**CALIFORNIA ENERGY COMMISSION**

**NOTICE OF DETERMINATION  
 PETITION TO INCLUDE AN ADDITIONAL  
 LAYDOWN AND PARKING AREA  
 FOR THE OAKLEY GENERATING STATION  
 (09-AFC-4C)**

**DOCKET****09-AFC-4C**DATE OCT 06 2011RECD. OCT 06 2011

**Figure 1**  
**OGS Permanent and Proposed Temporary Disturbance Areas**  
 Oakley Generating Station  
 Oakley, California

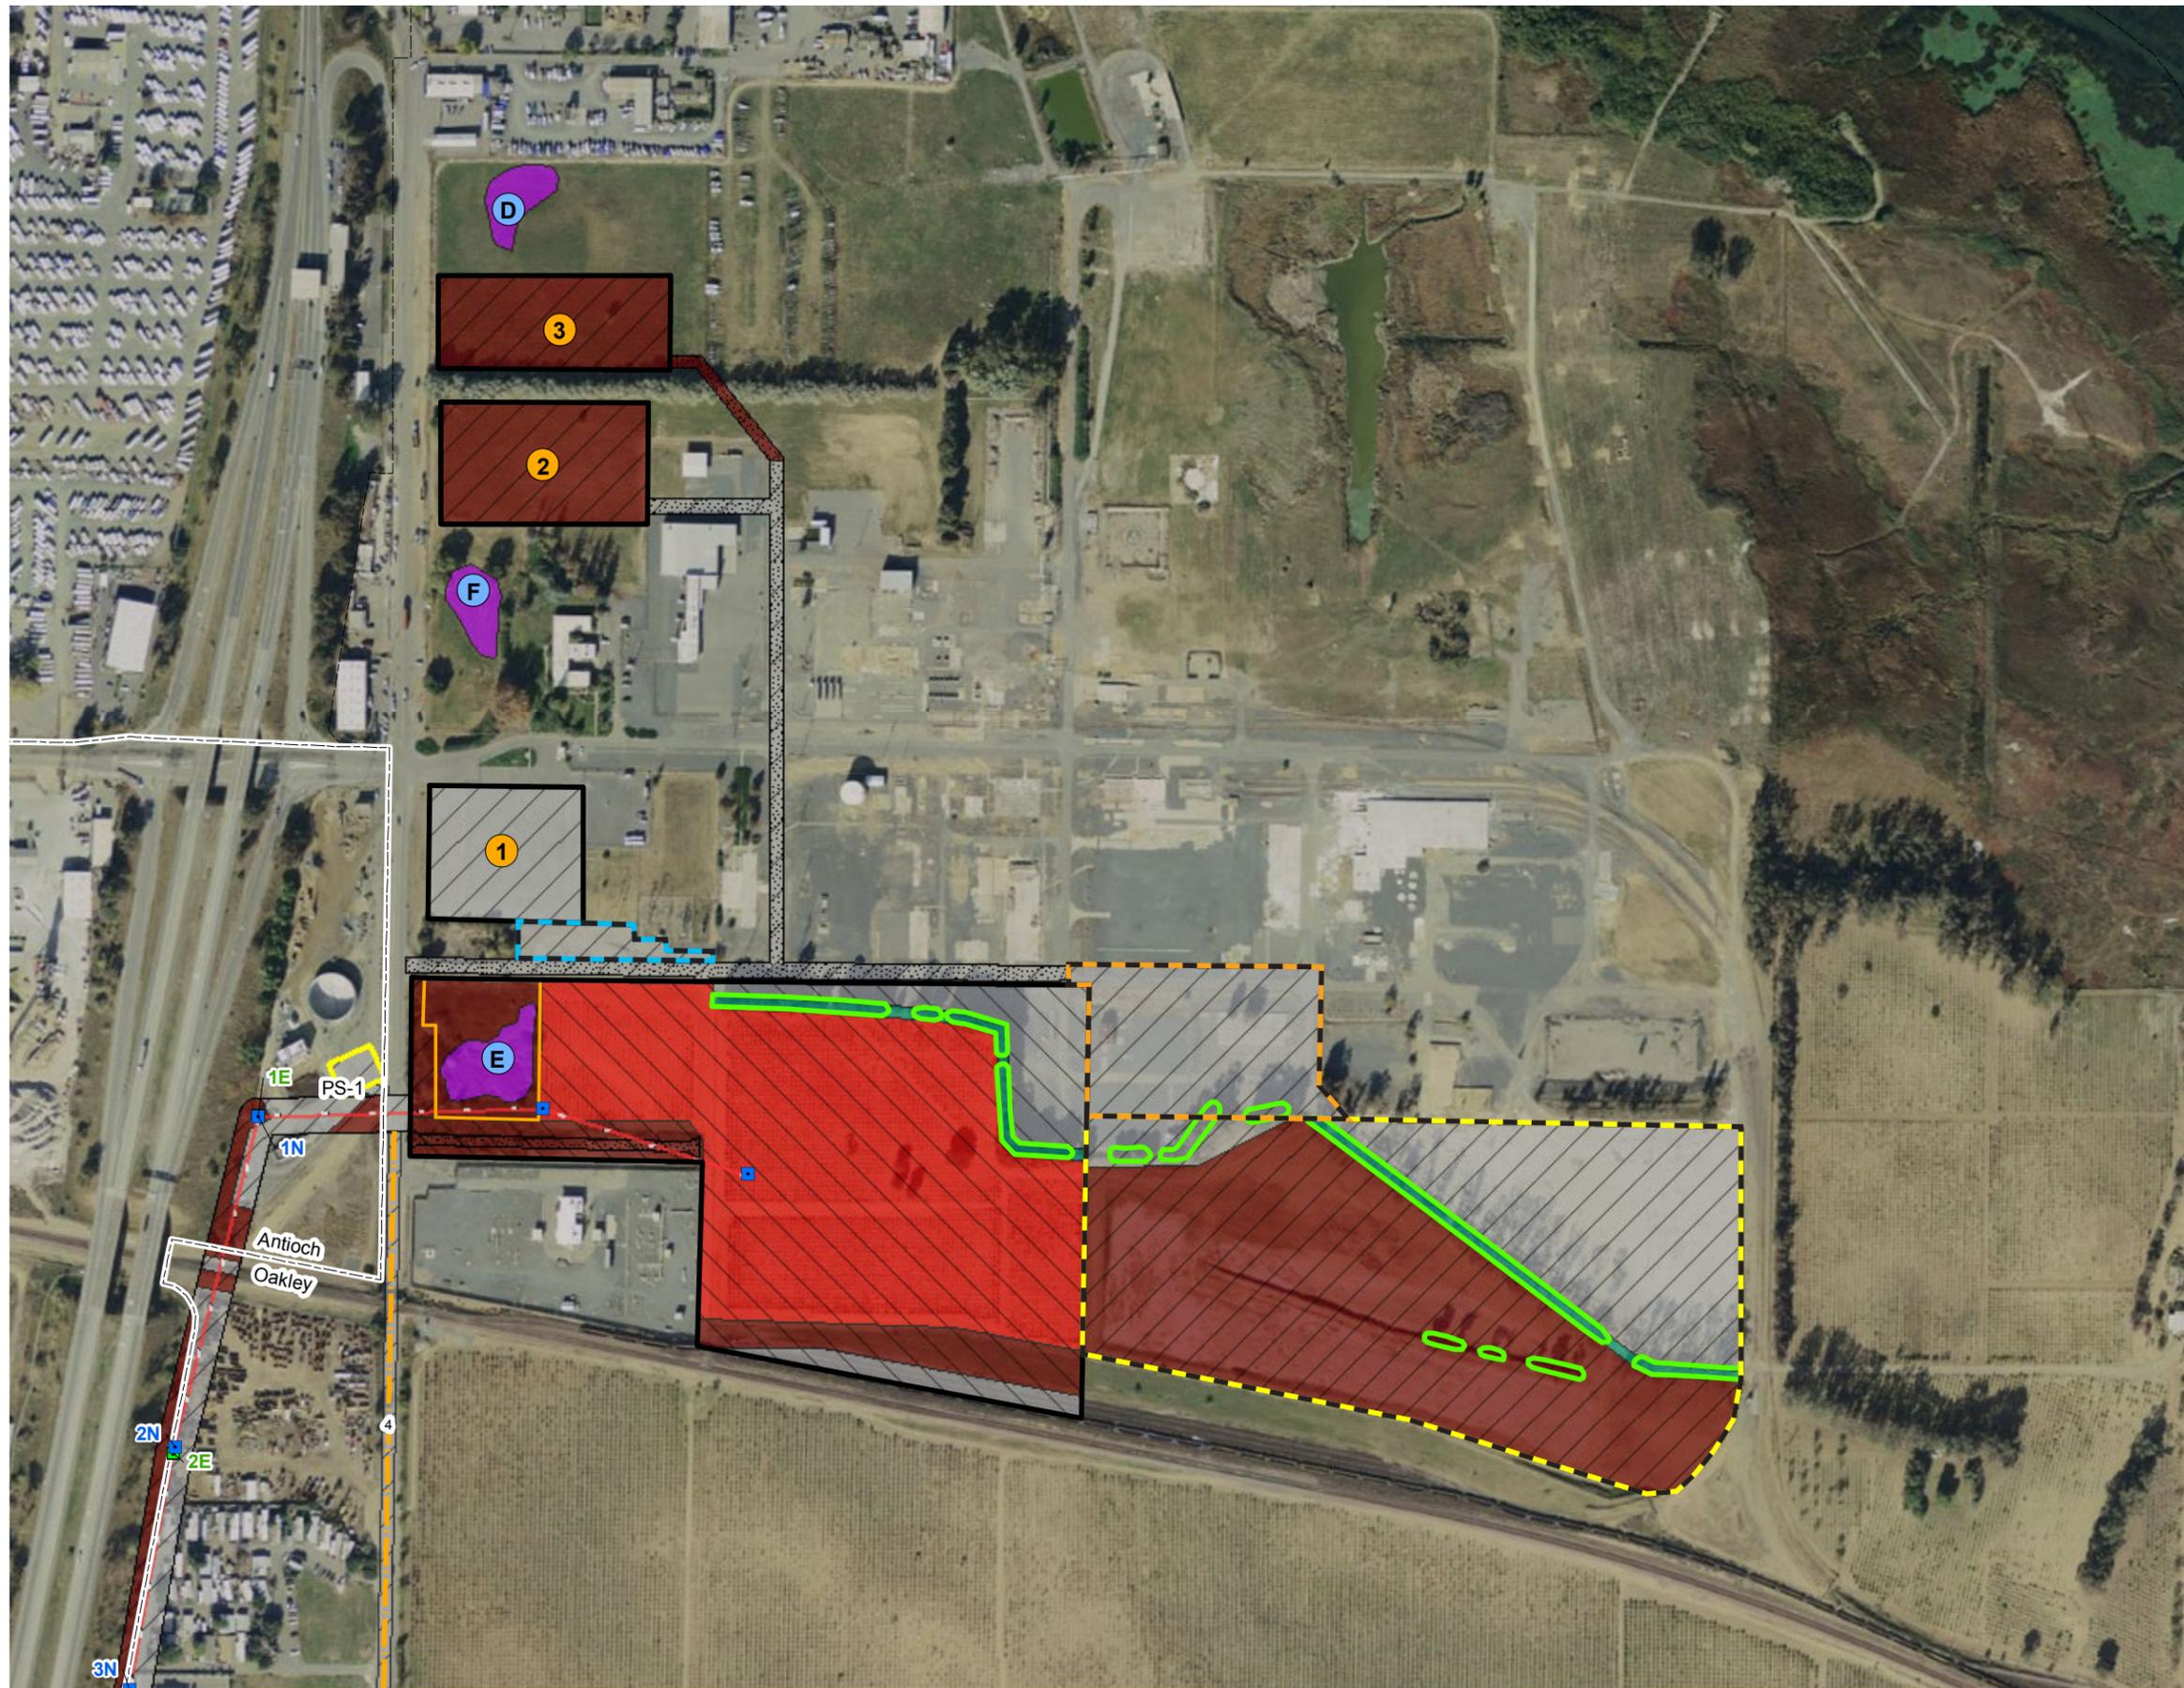
The purpose of this modification is to include an additional 4.64 acres of laydown and parking area adjacent to the OGS power block site. The additional laydown and staging areas are within the DuPont site and have been previously disturbed.

The location of the proposed 4.64-acre additional laydown/parking area, which would be used primarily for construction contractor parking and occasional temporary supplementary equipment laydown or assembly, and the 0.56-acre plot located between 5th Street and Stockpile 1, which would be used for staging vehicle movement along the proposed access route, are identified on the attached map. The additional laydown/parking area is almost entirely paved, with some small portions of gravel or hard-packed dirt.

Access to the new parking/laydown area would be from Bridgehead Road along an approximately 1,400-foot portion of an existing paved road designated by DuPont as 5th Street, which travels along the northern border of the power block site. The proposed 0.56-acre temporary vehicle staging area is located between the proposed access route along 5th Street and Stockpile 1. This area was formerly used by DuPont as a truck wash station.
